PLANNING COMMISSION

SITE AND DESIGN REVIEW STAFF REPORT

FILE #: DR 14-01

Prepared for the April 14, 2014 Planning Commission Meeting

BLDG "C"
SITE DETAILS

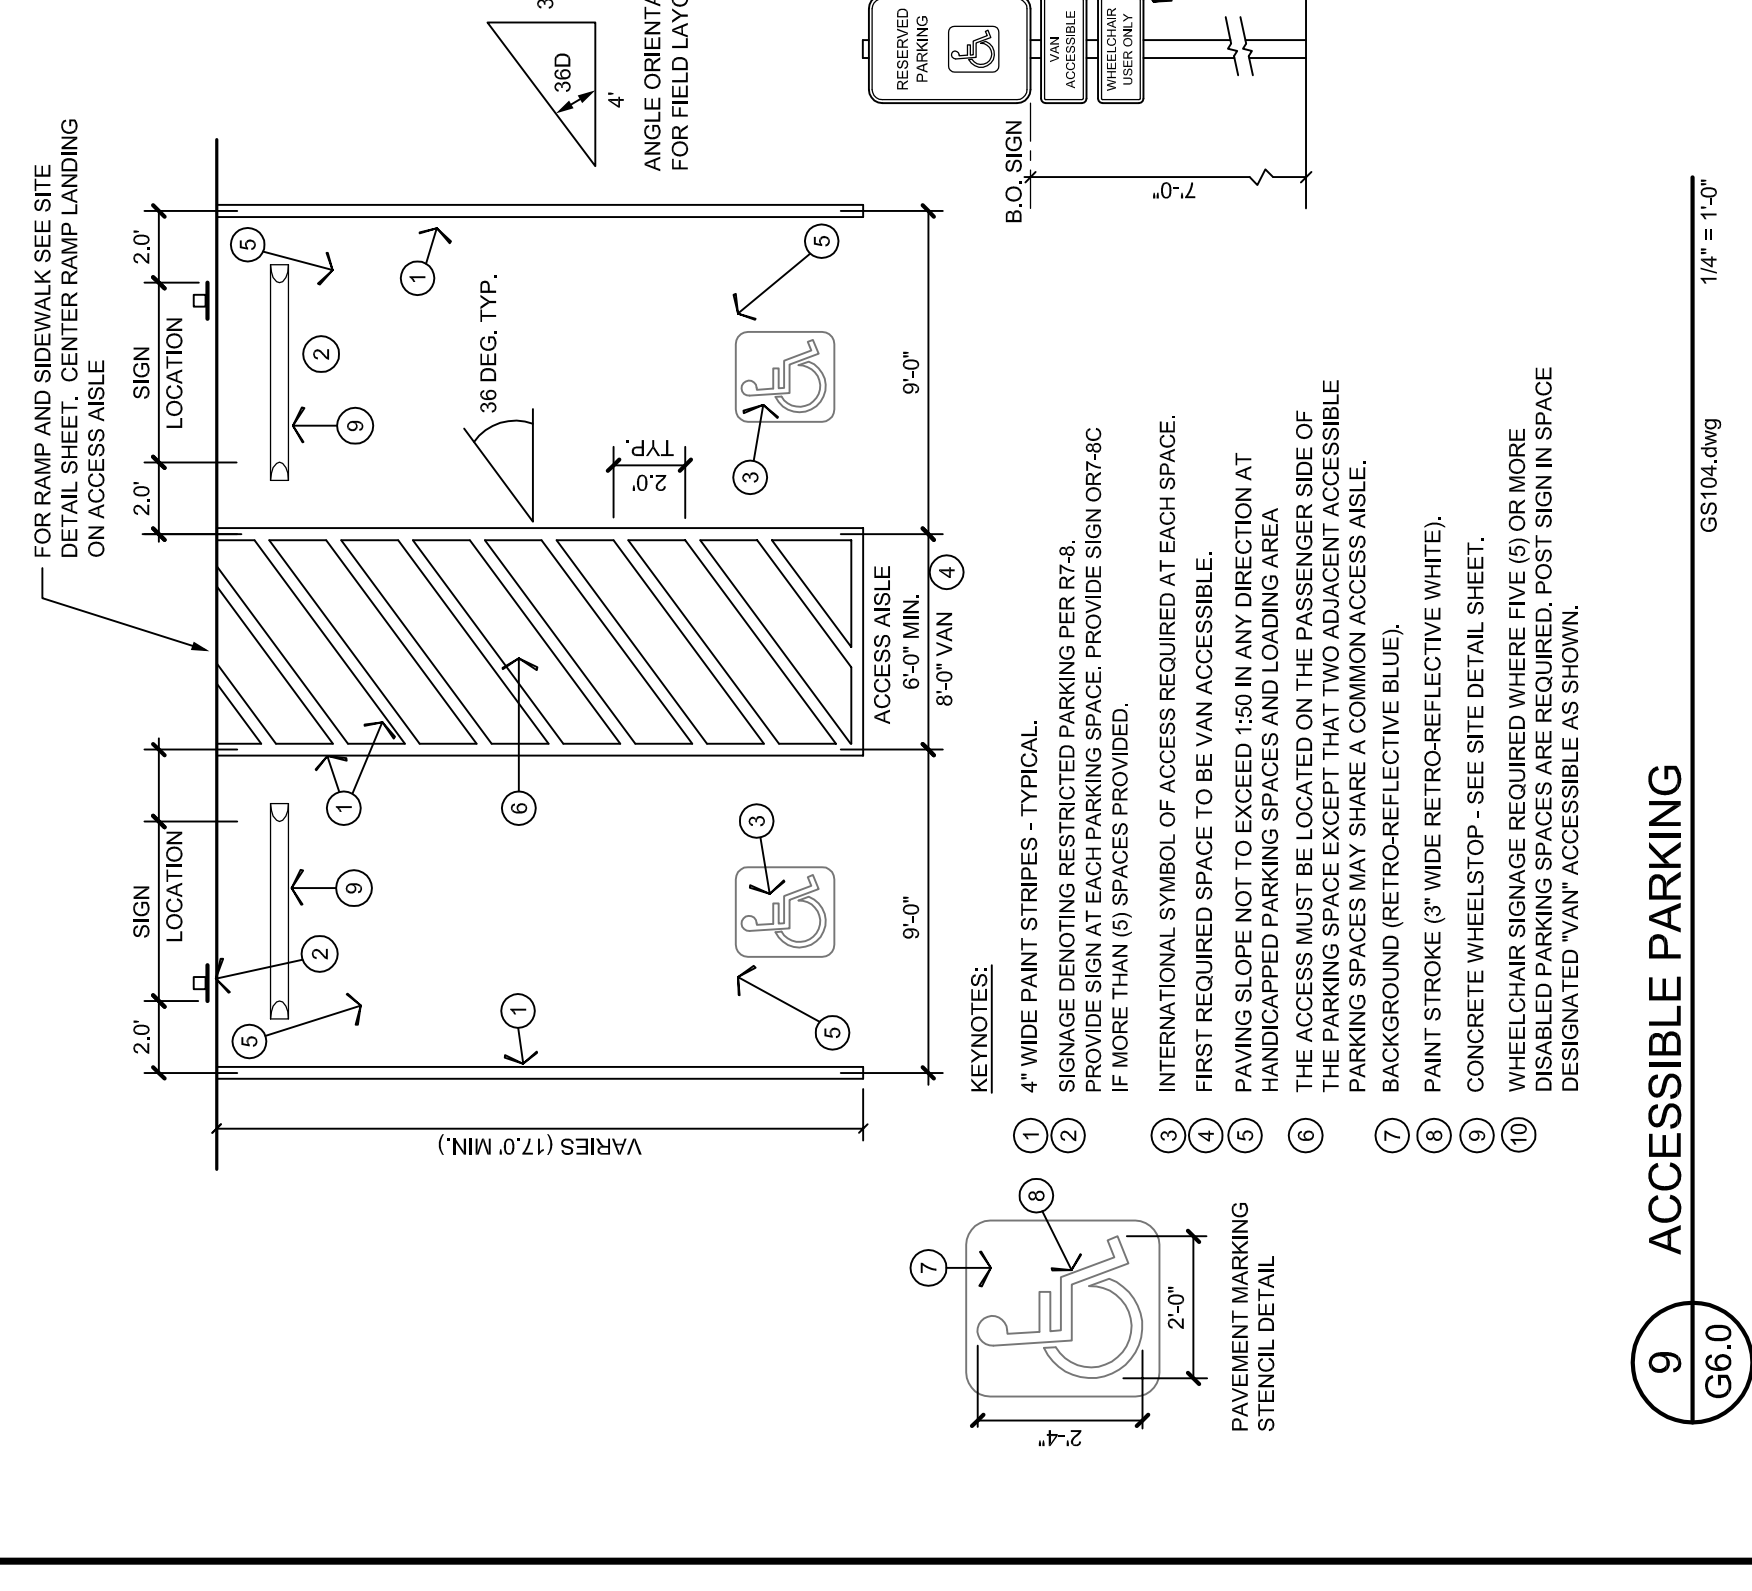
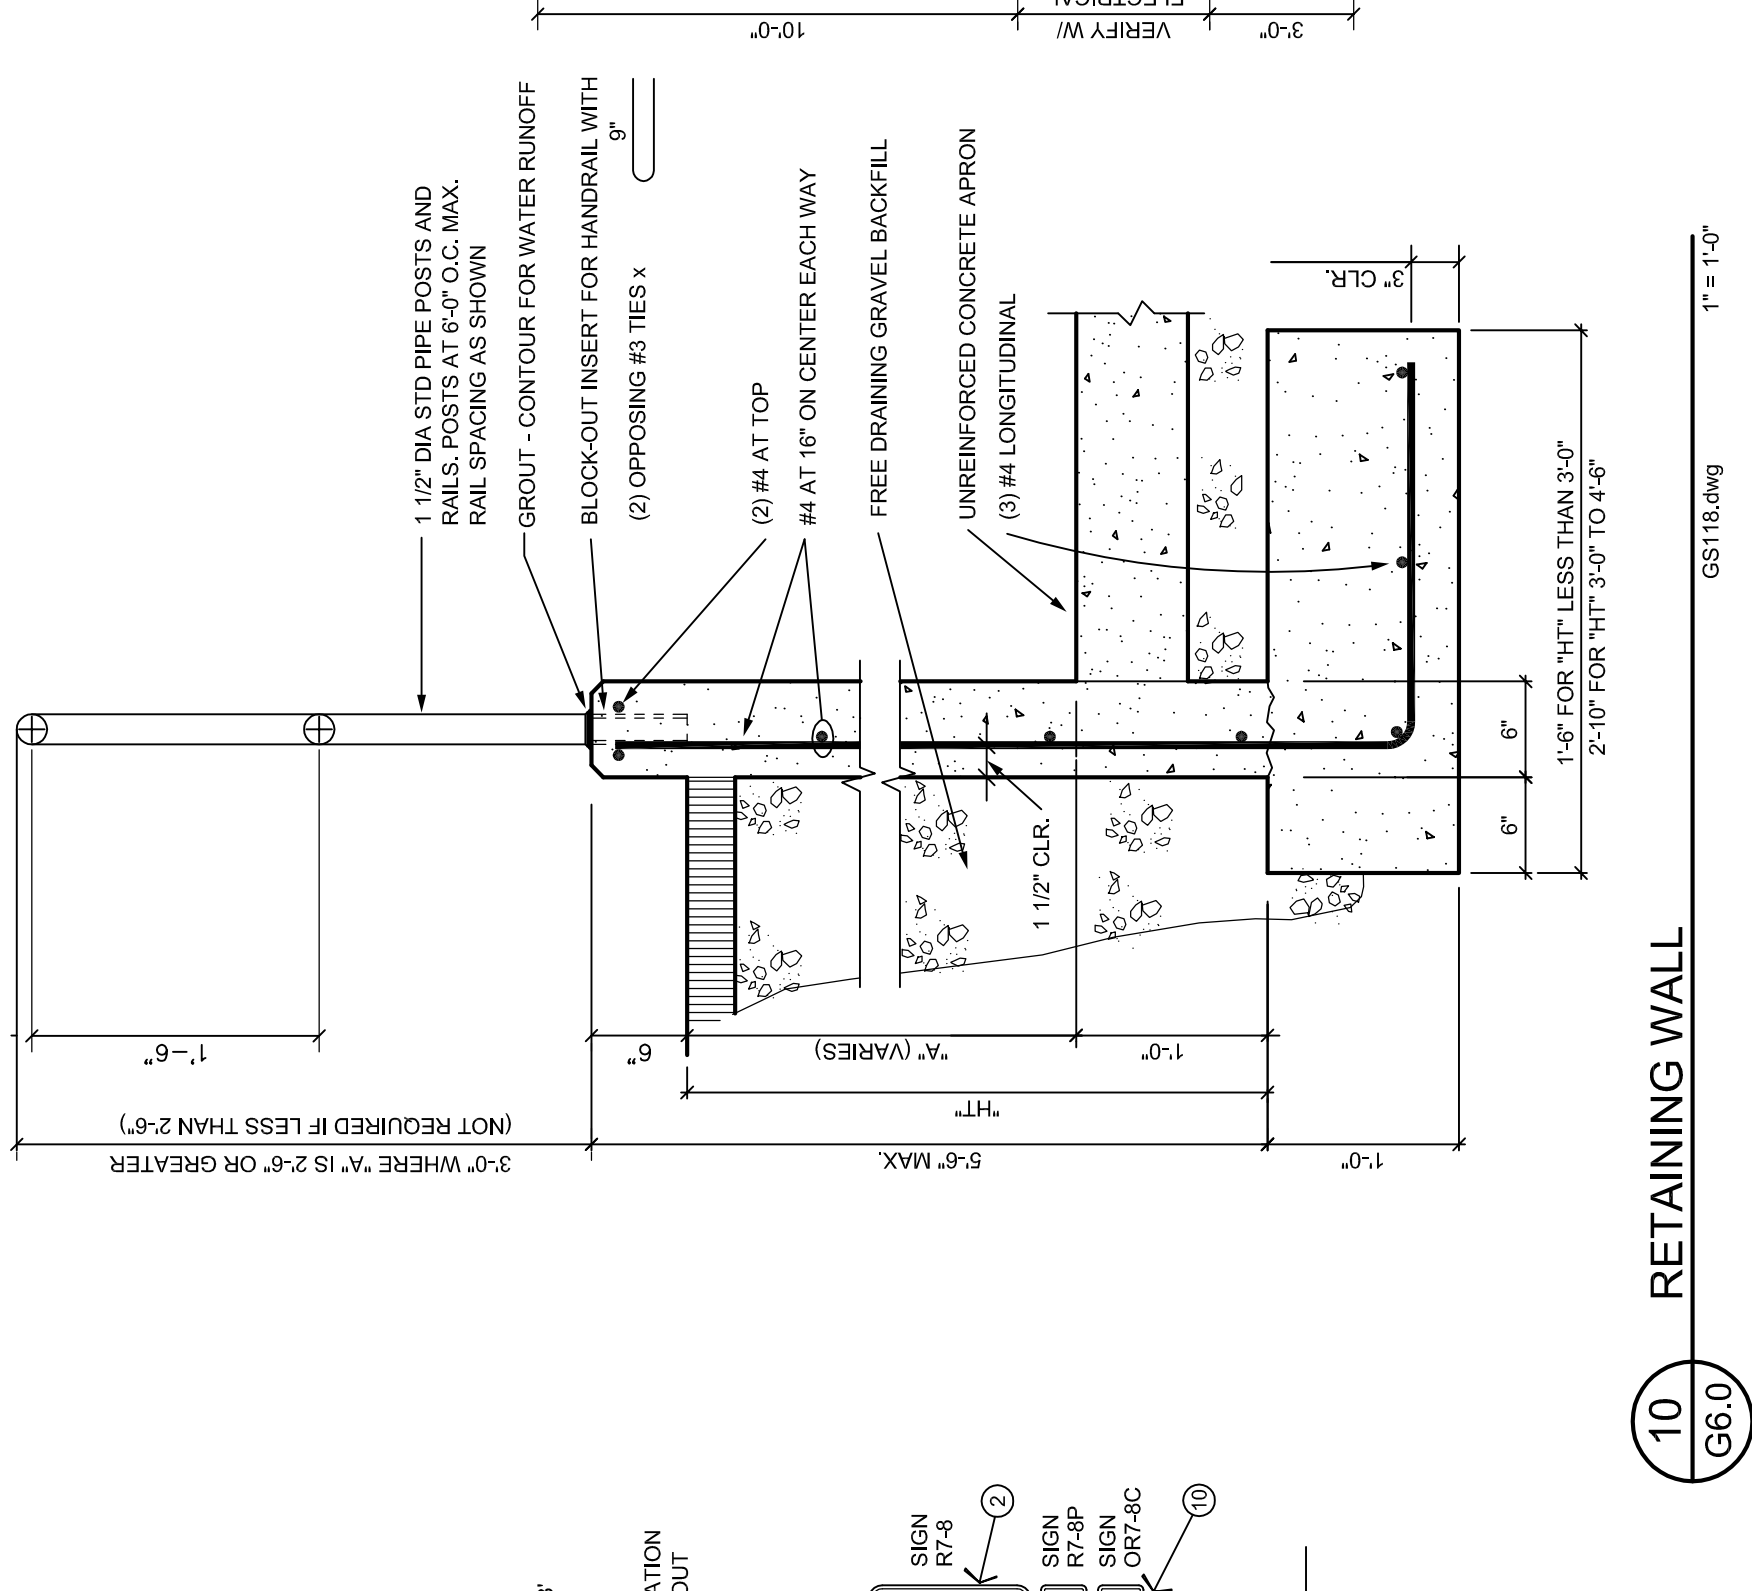
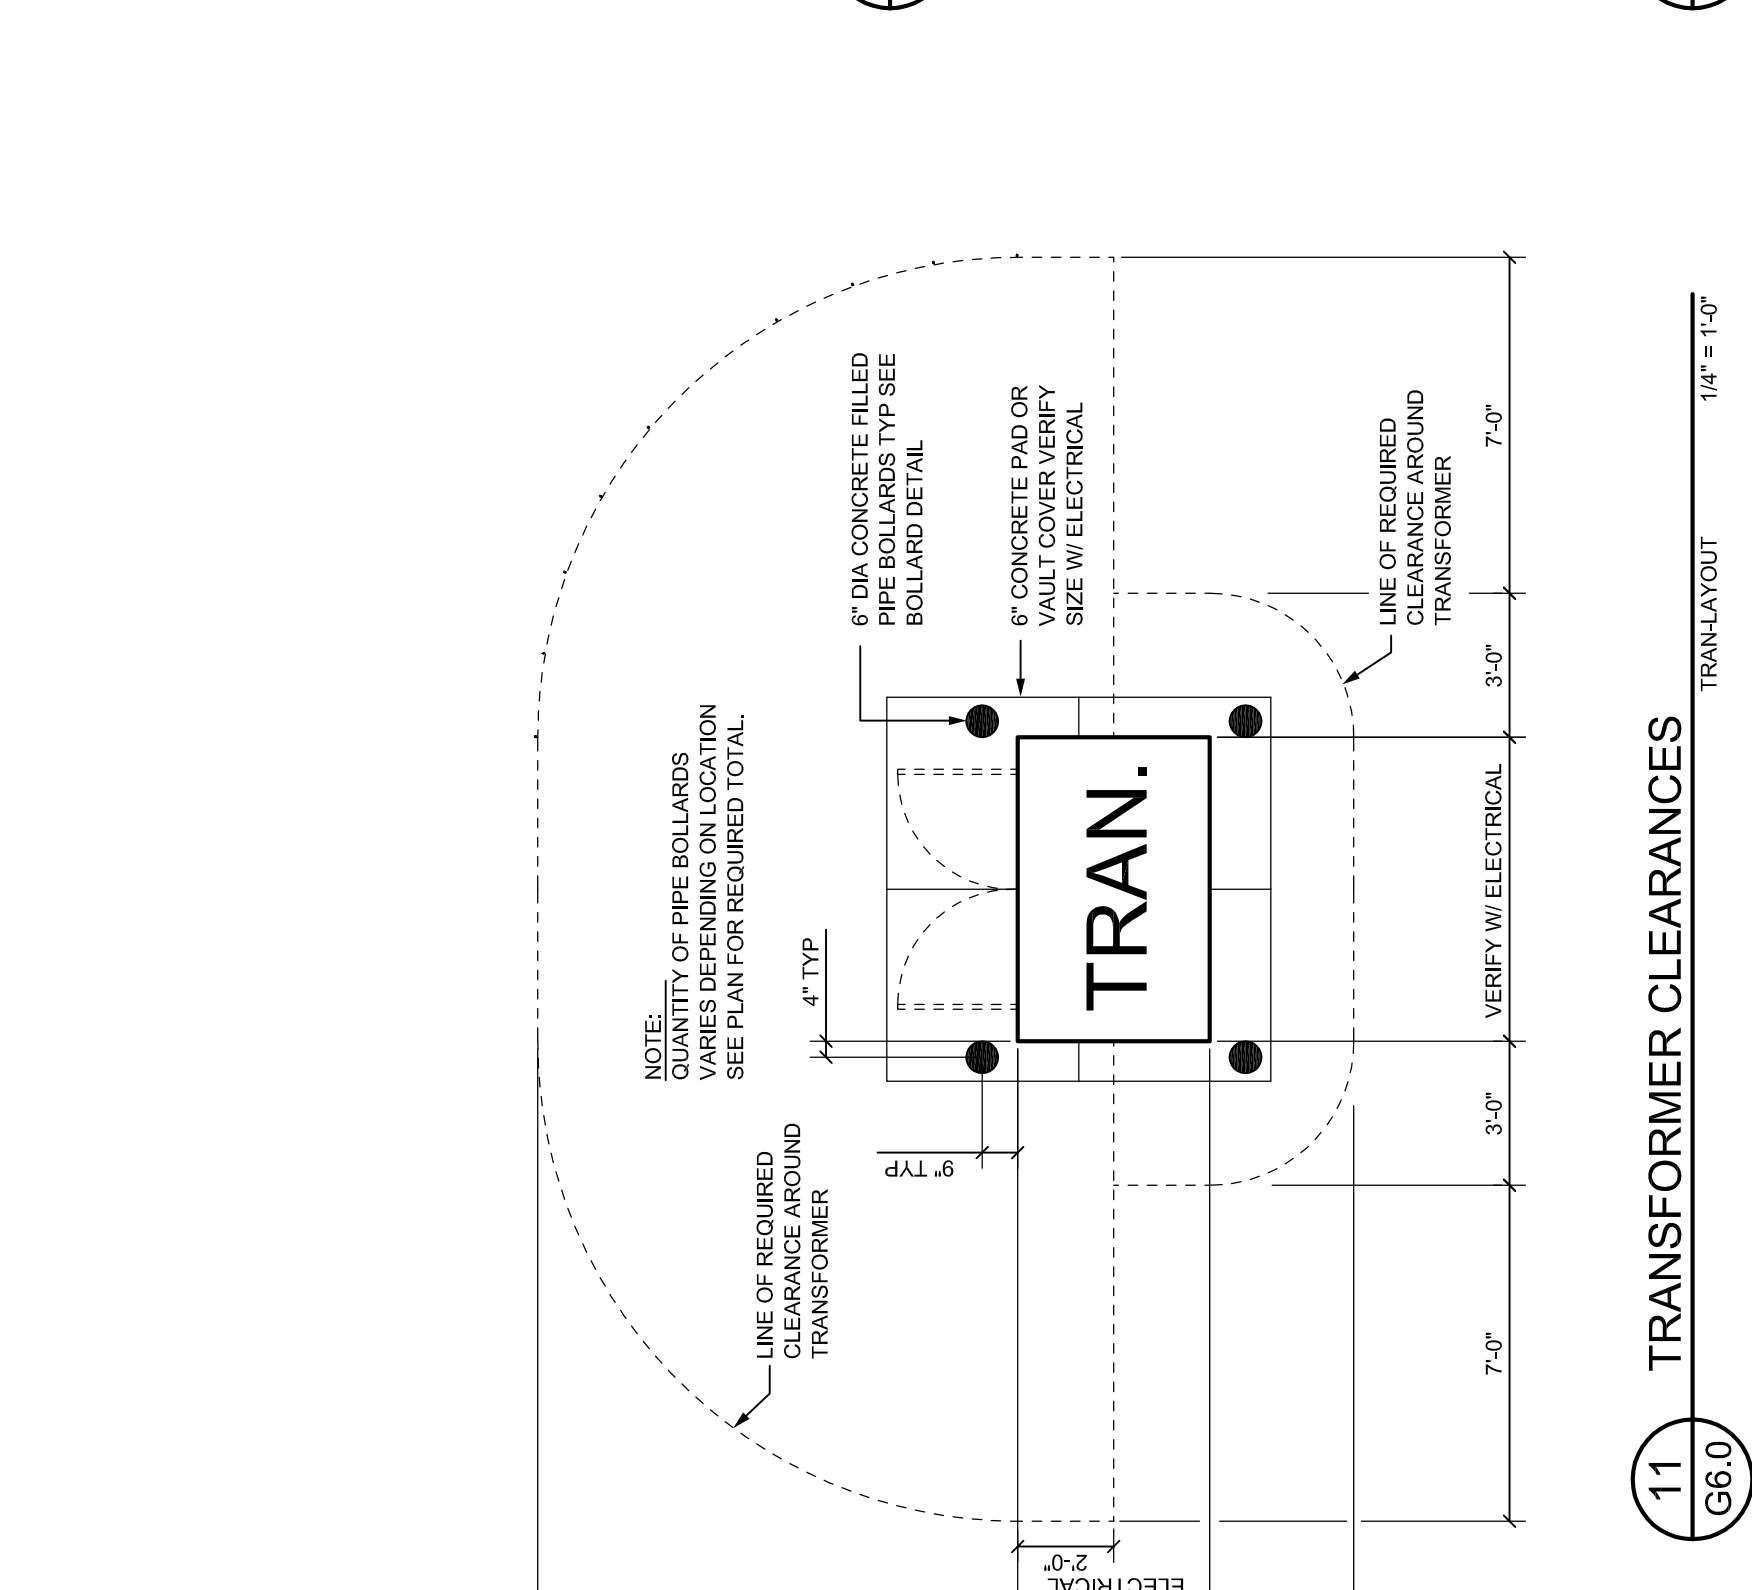
Findings: This code sections requires parking bumpers or wheel stops to prevent cars from encroaching onto streets, landscaped areas, or pedestrian walkways. Drawings 1 and 12 on page G6.0 “Site Details” show the proposed cross section of the on-site walkways and typical curb sections. These drawings show wheel stops, but the applicant verbally stated that they prefer to not

have wheel stops for liability reasons. All landscape areas adjacent to parking areas are could be protected with a curb with no wheel stops, and the walkways are raised 6" and could also serve as a bumper. However, no wheel stops can result in vehicle overhang into walkways/landscaped areas. The Planning Commission may require wheel stops along walkways and landscaping areas as it deems appropriate.

Five bicycle parking spaces are required (see 16.10.100(C) below). The applicant is proposing one U style rack by the north entrance. U style racks can hold up to three bikes if they are parked as depicted in Drawing 6 on sheet G6.0, but realistically only 2 bikes can be accommodated with U style racks because bikes are usually parked parallel to the "U". The applicant is also proposing one indoor rack to be installed at a later time, but an indoor rack may only accommodate one tenant if the building is leased to multiple industries.
